PERMIT

SEWAGE DISPOSAL SYSTEM

HOWARD COUNTY HEALTH DEPARTMENT

SUBDIVISION Buttercup Estates LOT 7

P 57034

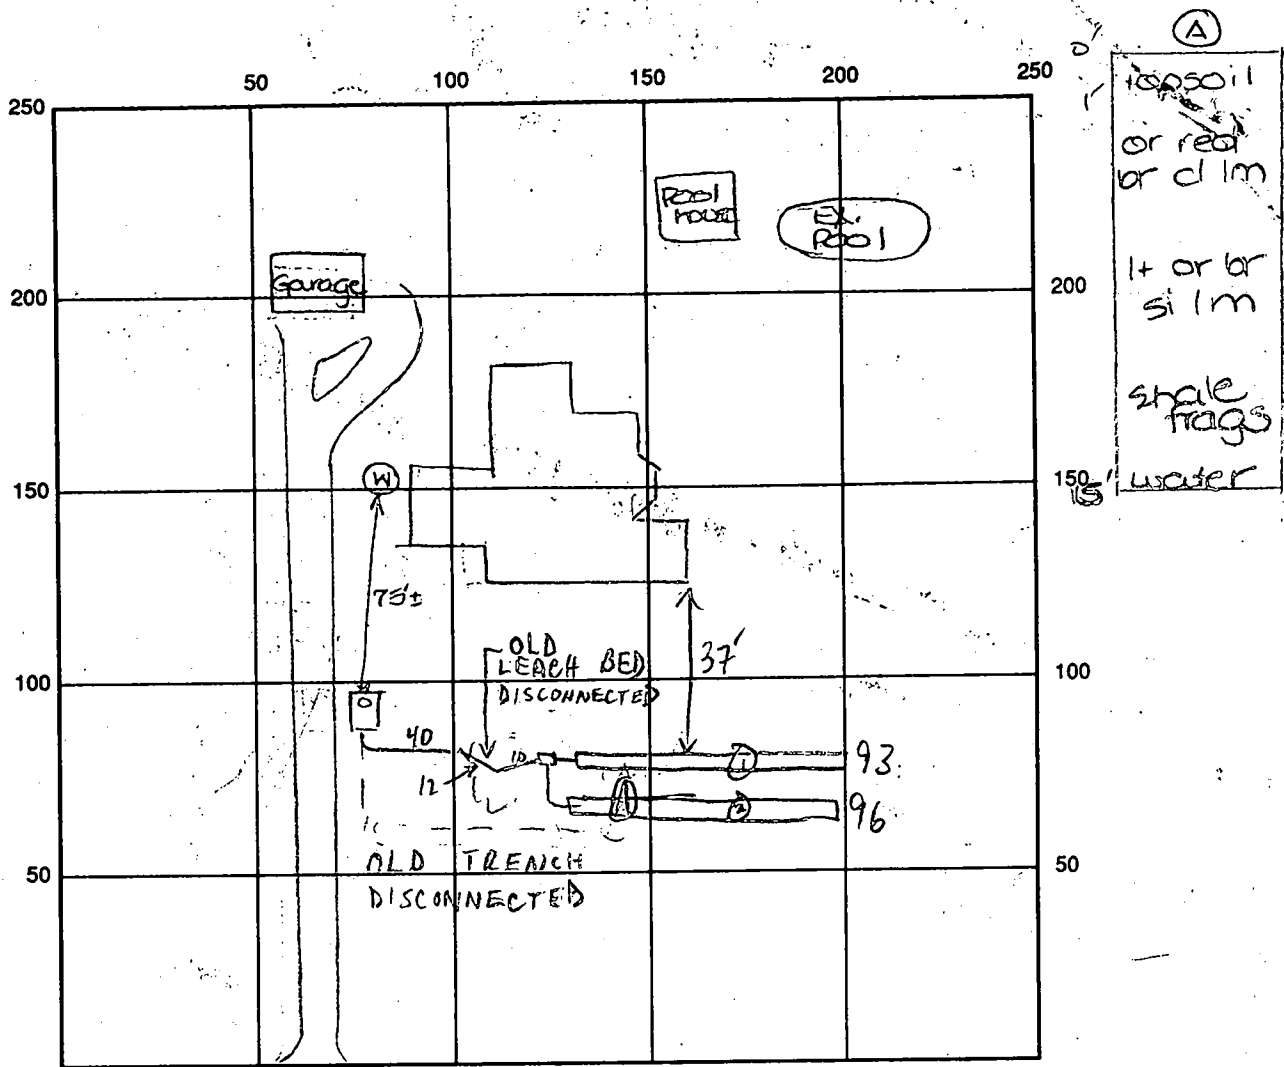
Trenches to be installed through passed perc hole
on contour parallel to road.

Trenches to be 2' wide, inlet 3' bottom 8' stone 5'.

REMARKS: 7/18/96 well not observed - location per owner. Perc hole
(A) OK. If necessary, trenches may be 10' deep w/
5' stone to have necessary fall. OK to start work. DCS
8/28/96 OK TO STONE, LEAVE ENDS OPEN FOR FINAL MR
8/29/96 Final inspection made AUW
